Meeting Minutes

Date: 31 March 2009
Project: Columbine Elementary School - BVSD
Meeting No: 2nd- D.A.T. Meeting

COLUMBINE ELEMENTARY SCHOOL
 SITE PLAN OPTION ONE

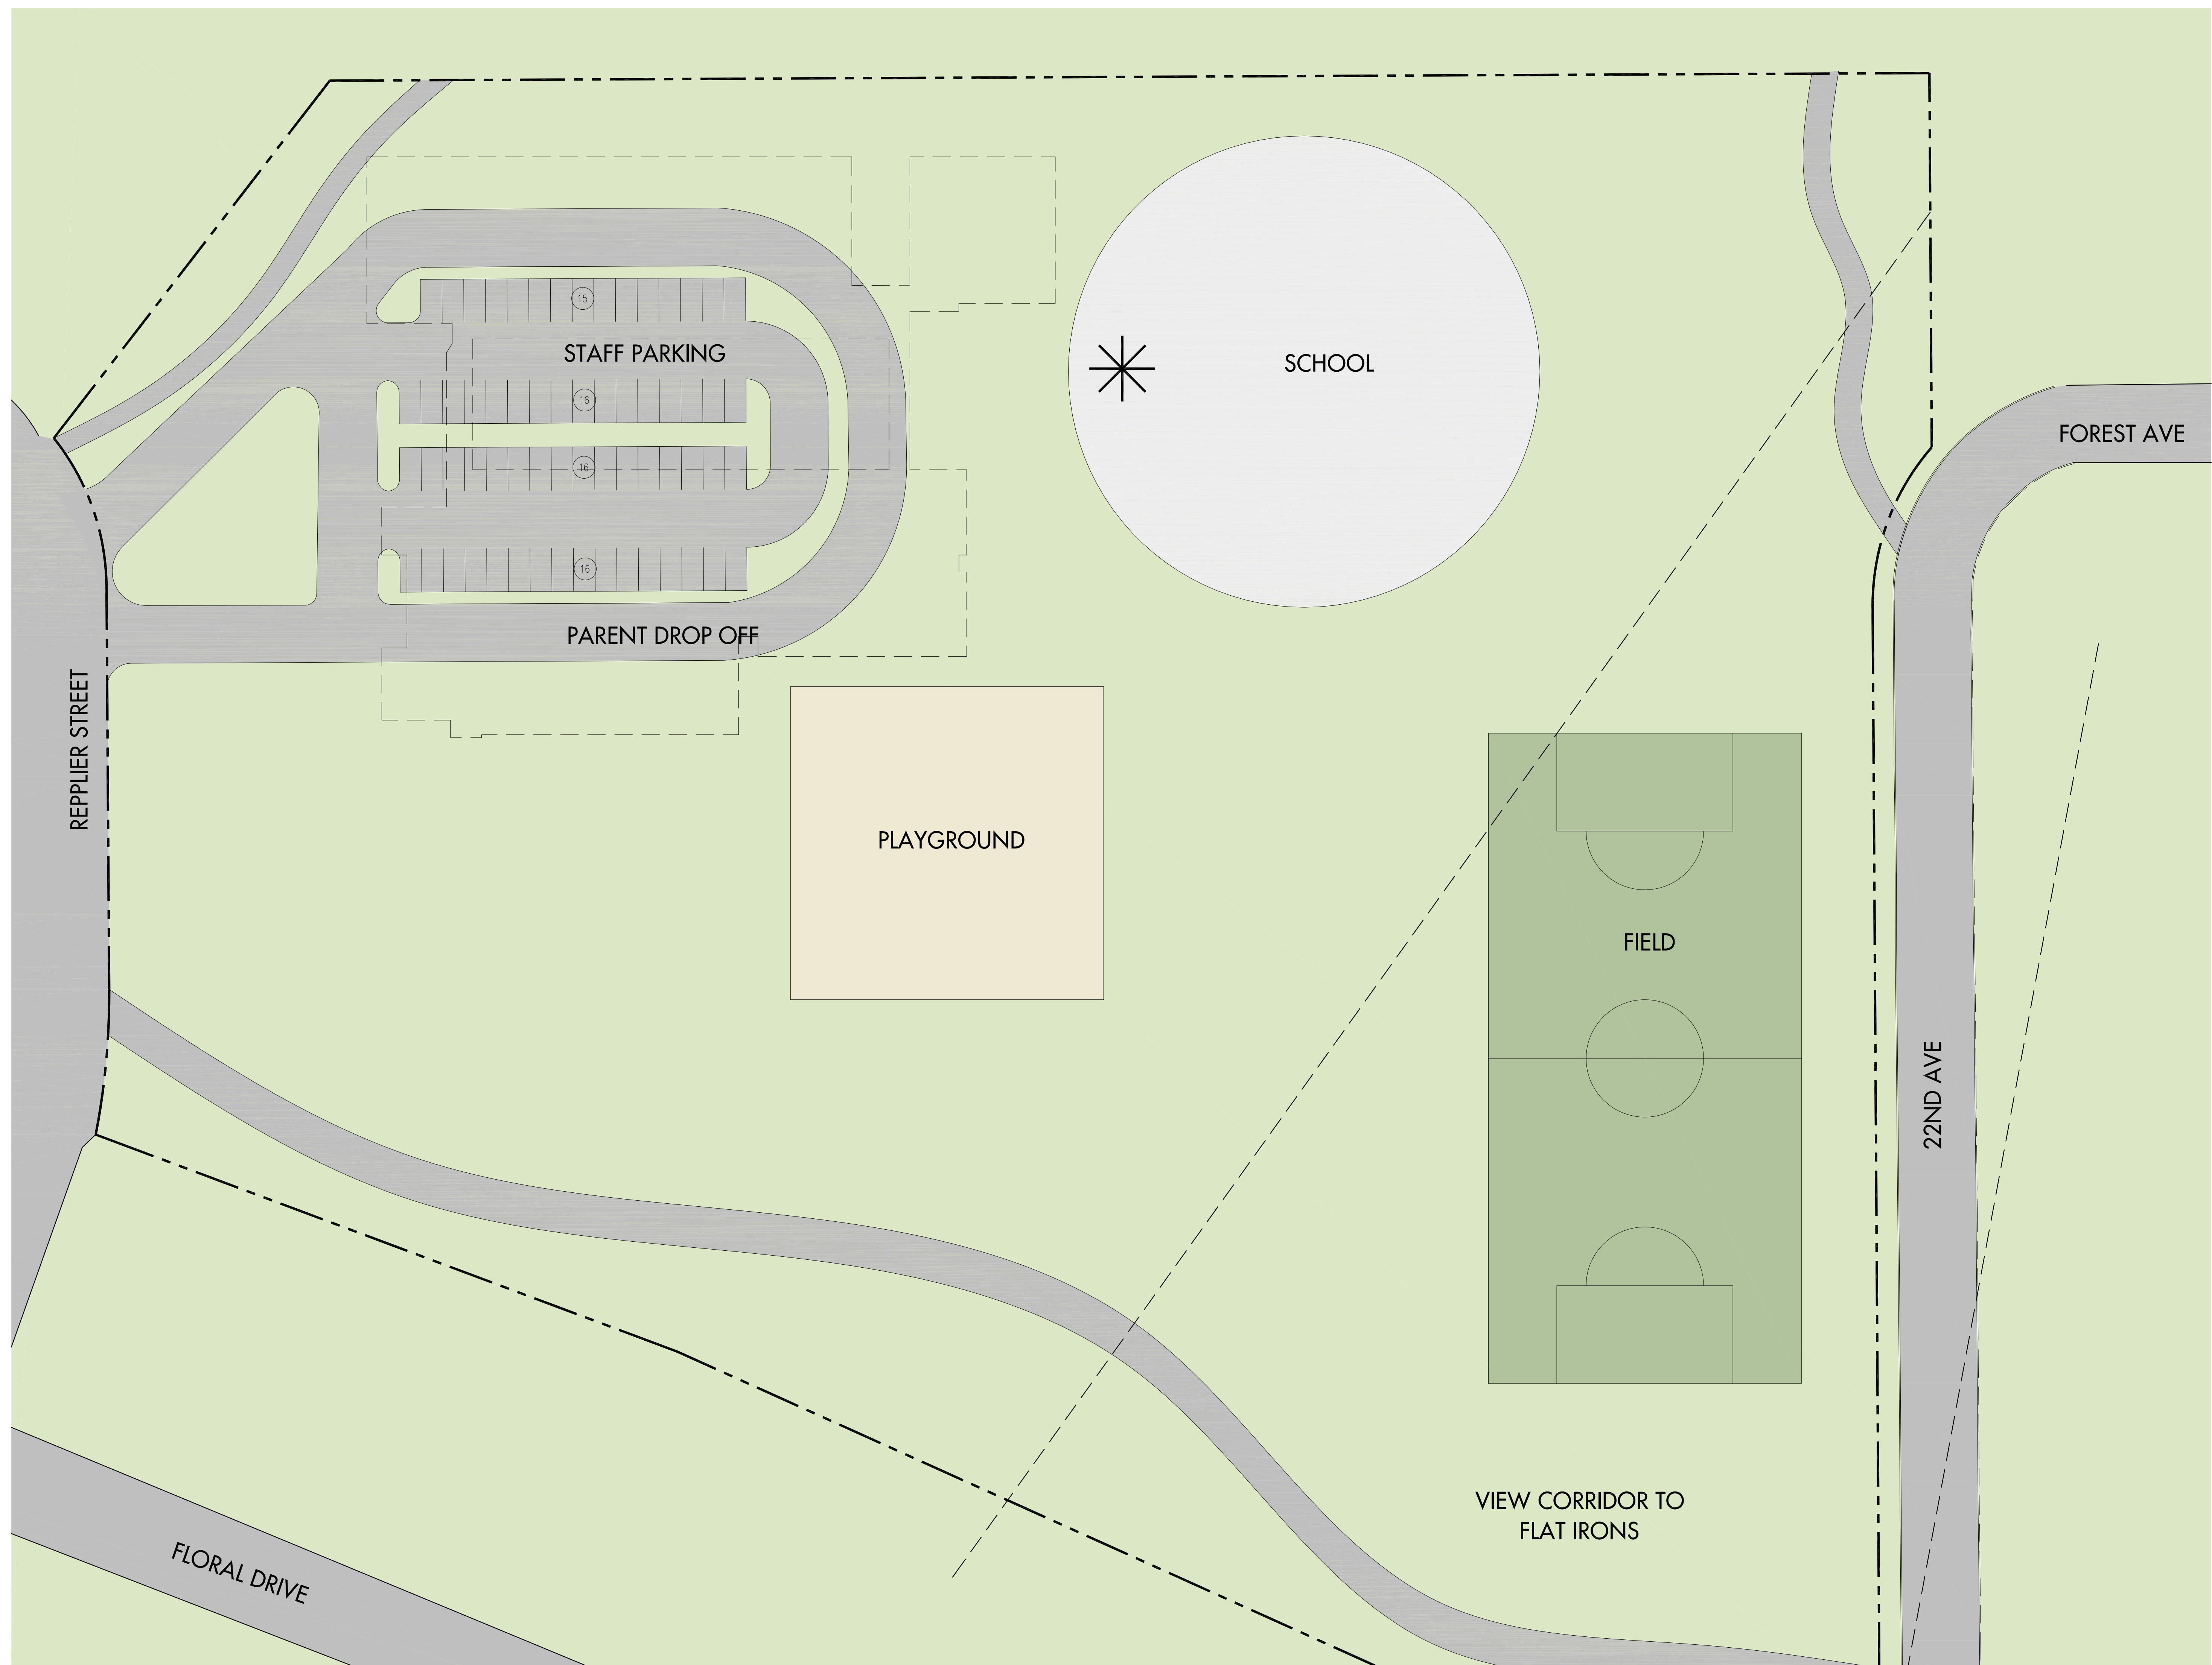
Option 1

- Maintains existing traffic patterns with the bus drop-off on 22nd and parents drop off of Replier, but significantly reduces waiting and stacking on Replier.
- The new building can be located as far north as possible.
- The parent drop-off on the west side allows for a west or south-west facing entrance to the building and a direct access to the play ground on the south
- The playground in the southwest quadrant of the site allows preservation of the large trees on site.
- Keeps the paved areas to a minimum

Option #1 is the favorite; suggestion to move the Southern leg of the driveway loop more South (on a diagonal) to further lengthen the parent drop-off drive on site.

- Look into making Repplier one-way
- Provide signage and curb design at the parent drop-off exit onto Repplier to only allow for right turn on Repplier
- Look at moving the parking lots outside the parent drop-off loop to eliminate the hazard of parent/child crossing the drop off lane
- Concern this still leaves most of the traffic burden on Repplier.

At the next meeting on 14 April, the design team will present conceptual floor plans for the building and variations on site plan #1

COLUMBINE ELEMENTARY SCHOOL
 SITE PLAN OPTION FOUR

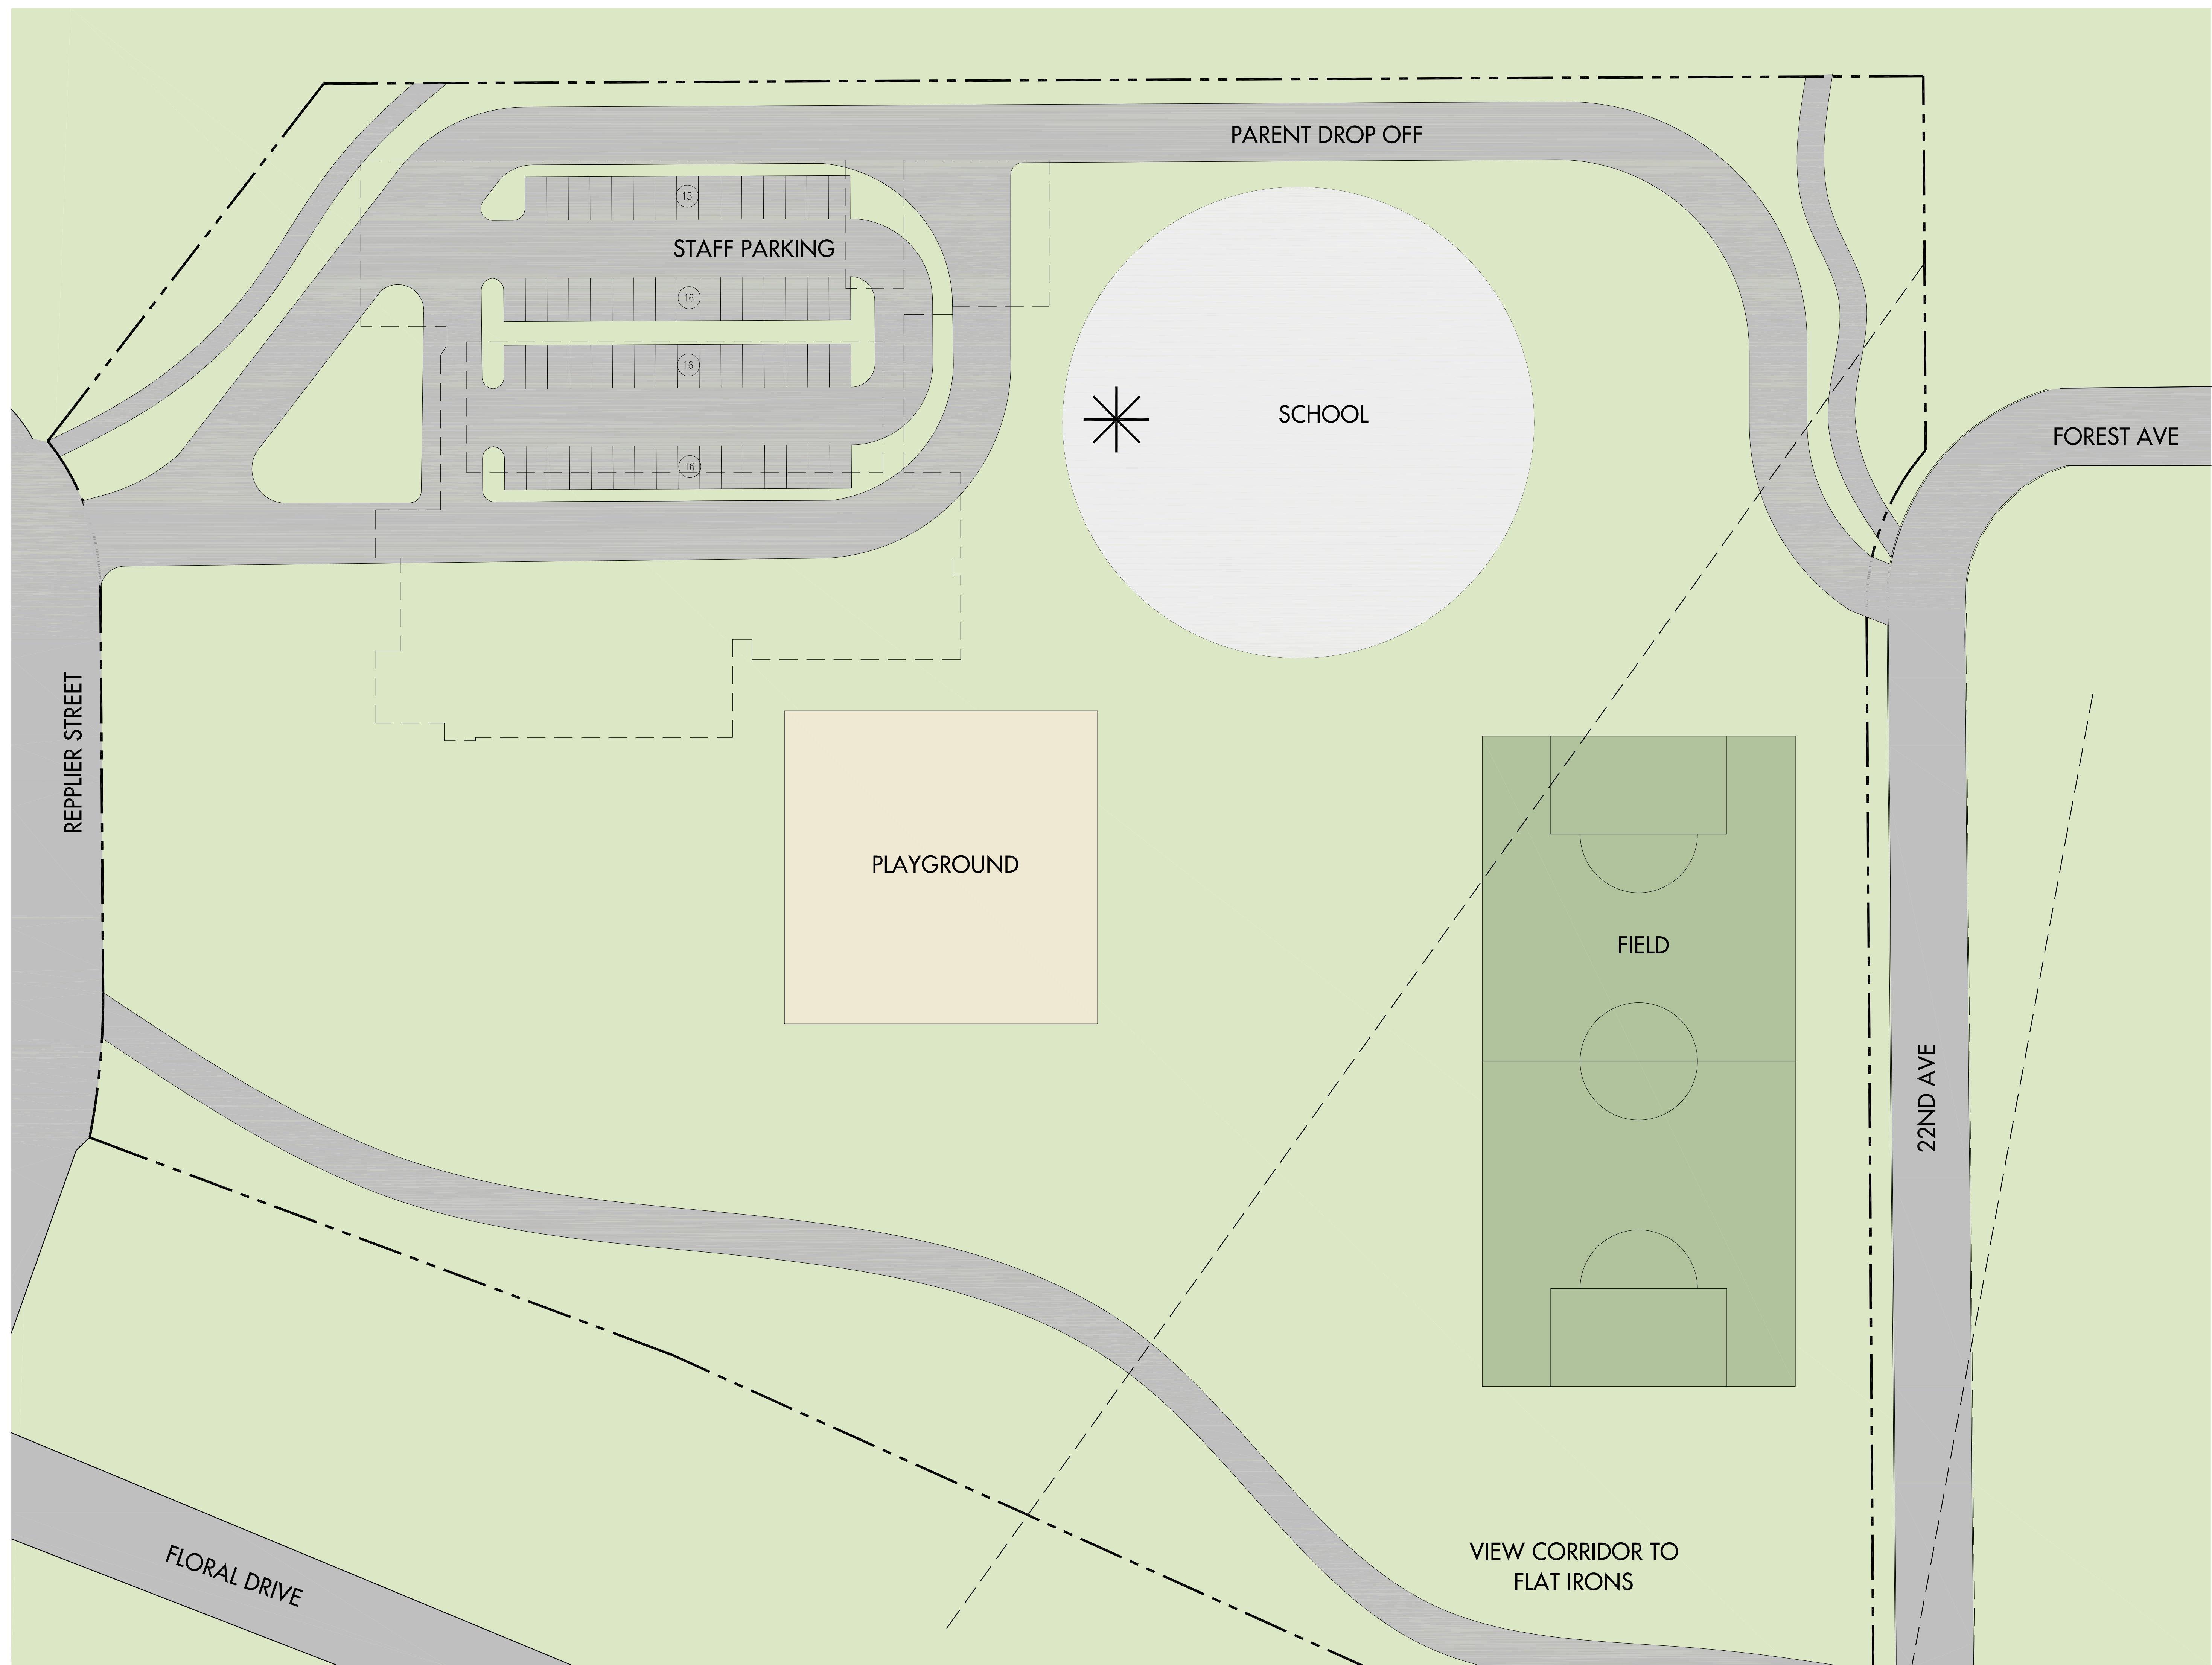
Option 4

- Combines option 1 and 3
- Maximum paving, but best traffic option to dissipate the parents cars east and west

Majority is opposed to the drive 60/40; however it is recognized that the east/west drive does have some benefits to dissipate parent traffic.
